Cabin John Village, Preliminary Plan No. 120180120

Cabin John Village, Preliminary Plan No. 120180120:

Staff Recommendation: Approval with conditions

SECTION 1 – EXECUTIVE SUMMARY

MC-201.01 vs Modified Section

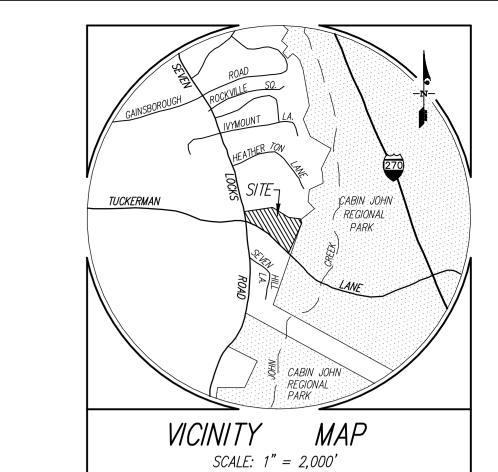
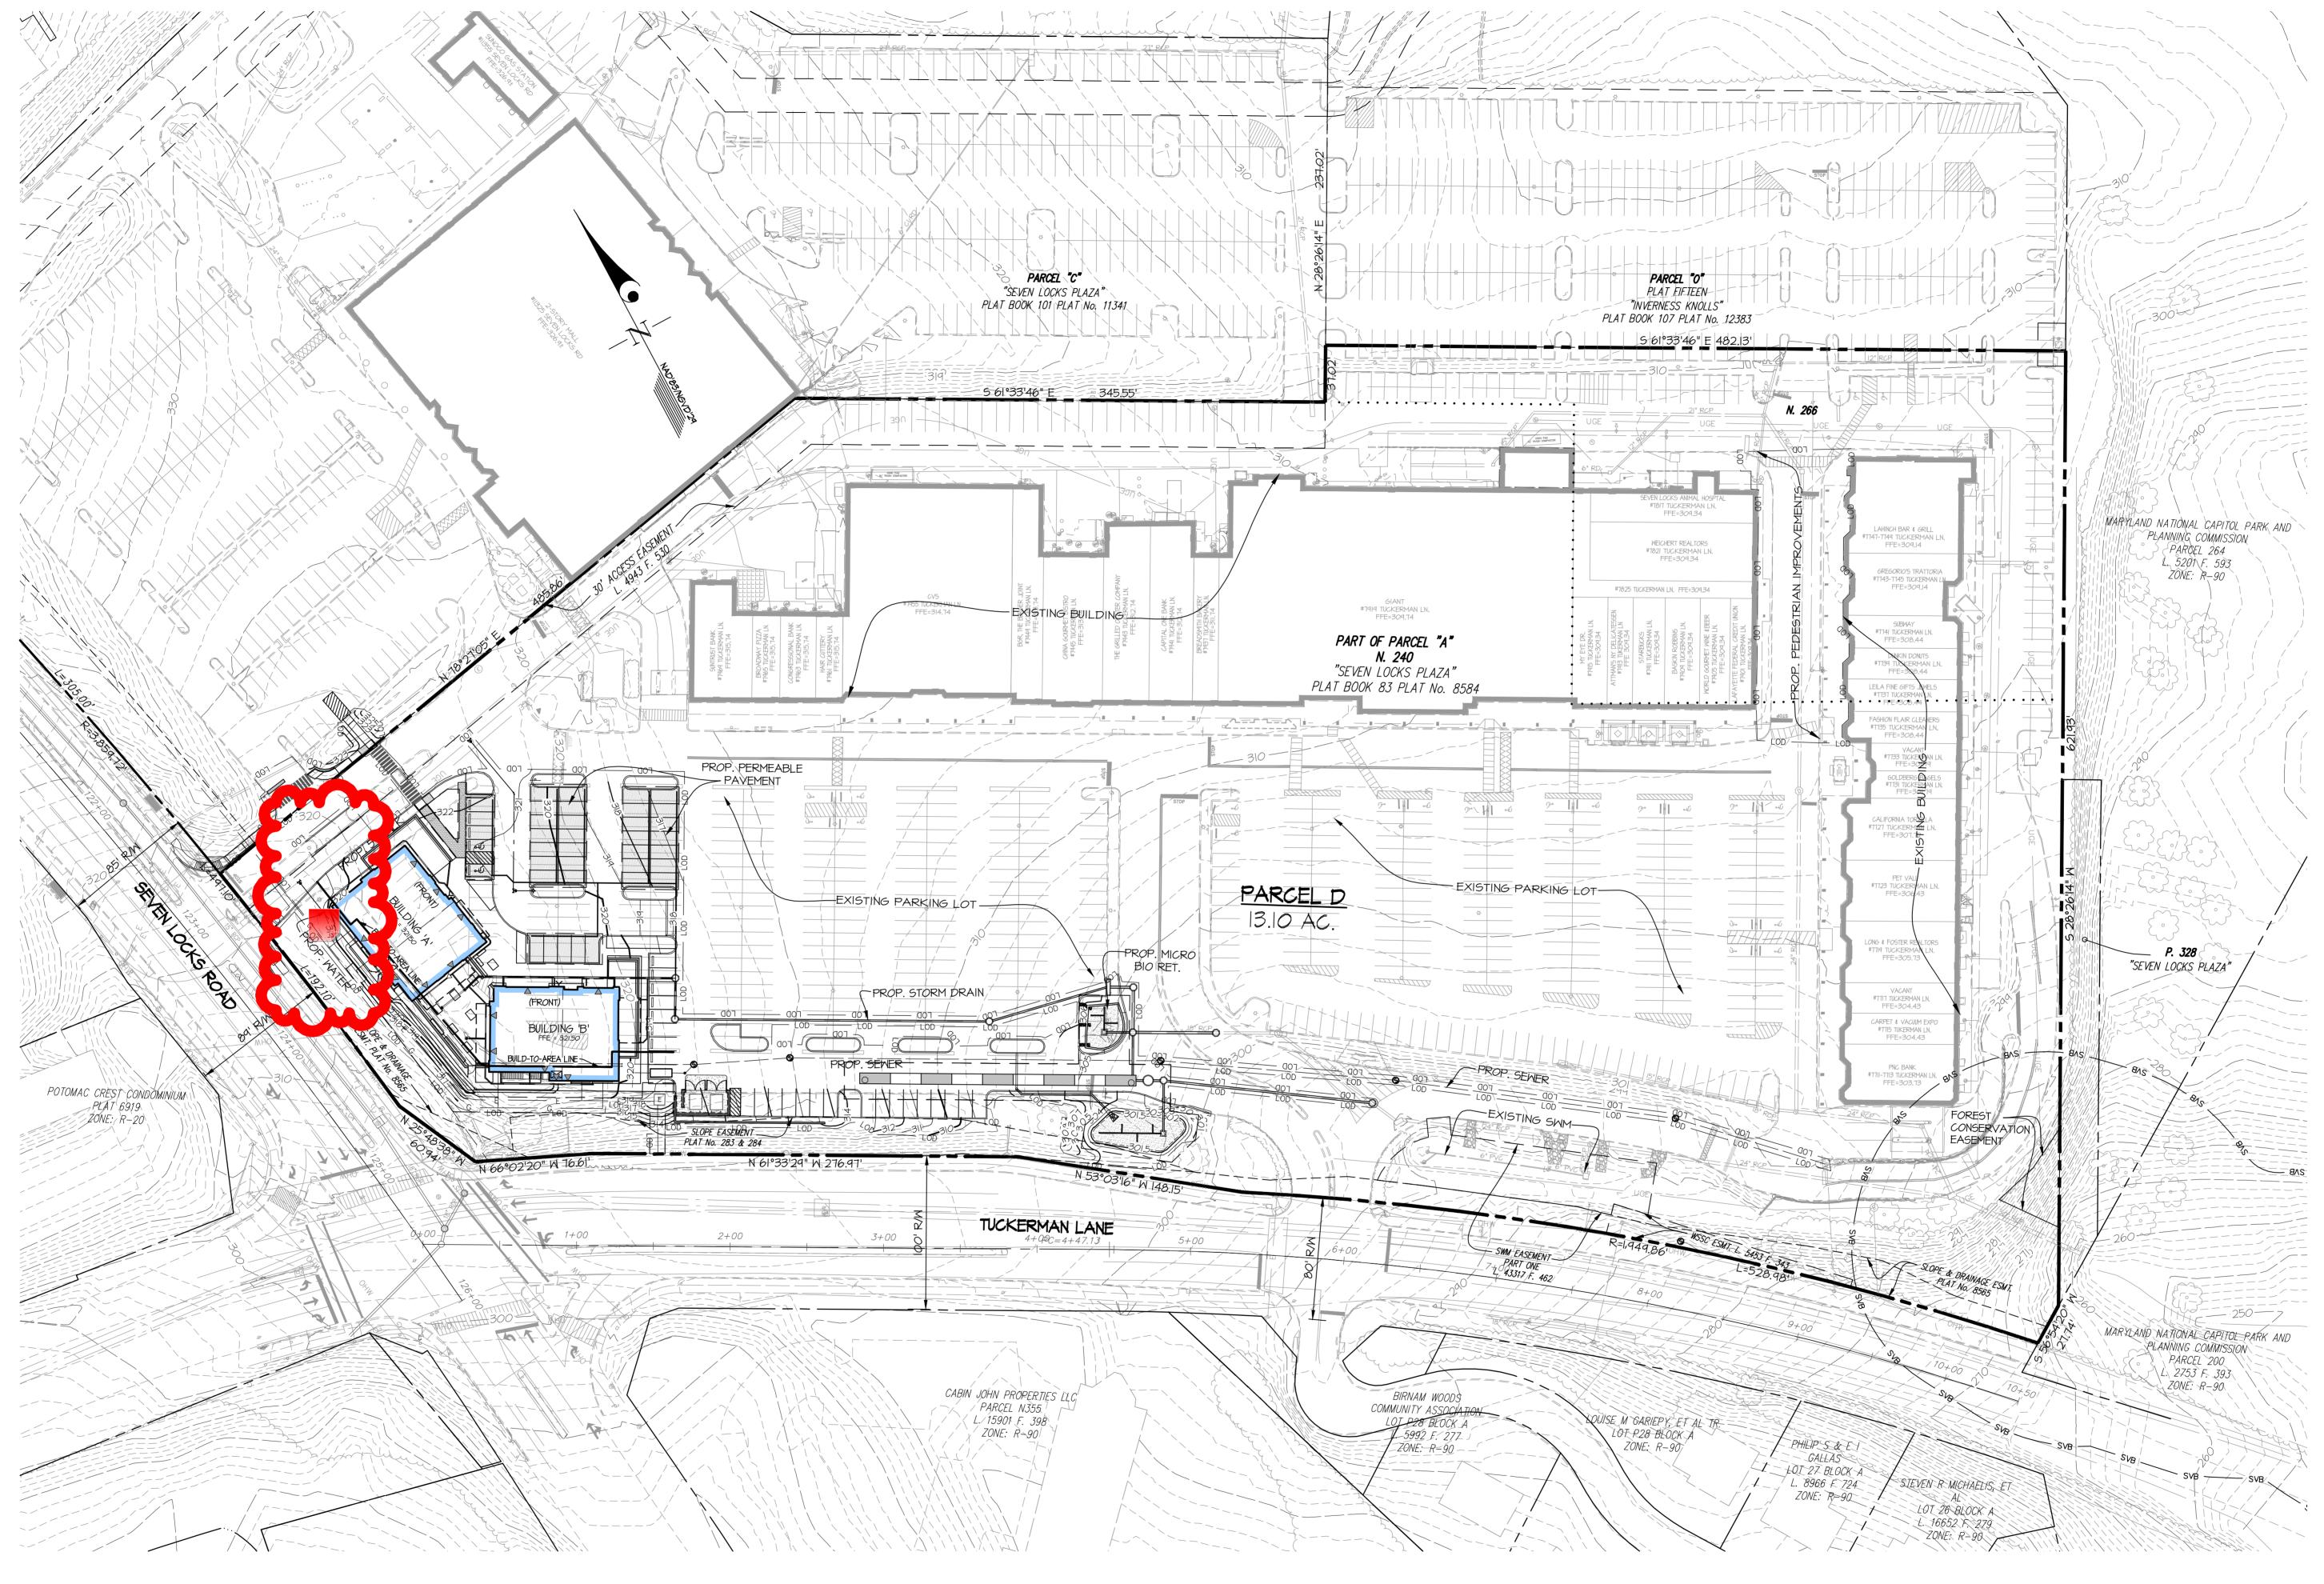
There is parallel parking on the left side of the modified section

The paving is wider on the modified section
